Access Compliance Report

Public Rights-of-Way

| Intersection ID: 50321 | Main Street: BELMAR_PLACE_RD | Cross Street: CINDY_LN | Location: NW |
| ADA ID: 691440BB7F98 | Ramp Type: Directional1 | Initial Pass/Fail: Fail | Overall Compliance: No |

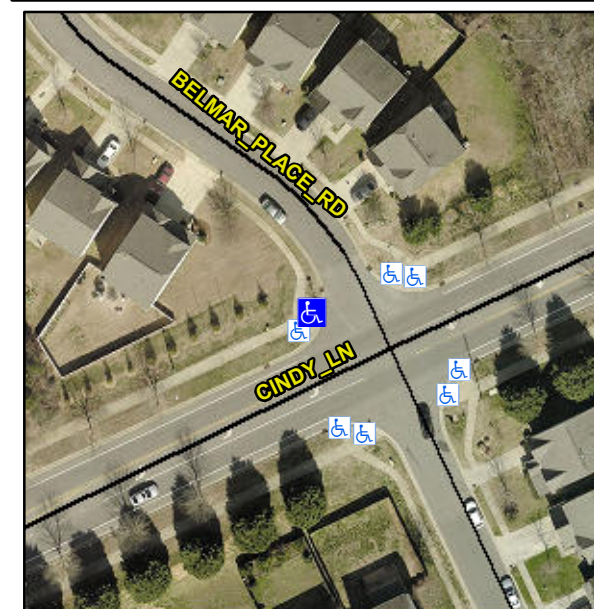
R304.2.2

| Compliance | Description | Data | Compliance | Description | Data |
|------------|-----------------------|------|------------|-----------------------------|------|
| No | Ramp Slope (%) | 10.0 | N/A | Grade Break XSlope (%) | 0.0 |

Remove & Replace Entire Ramp.
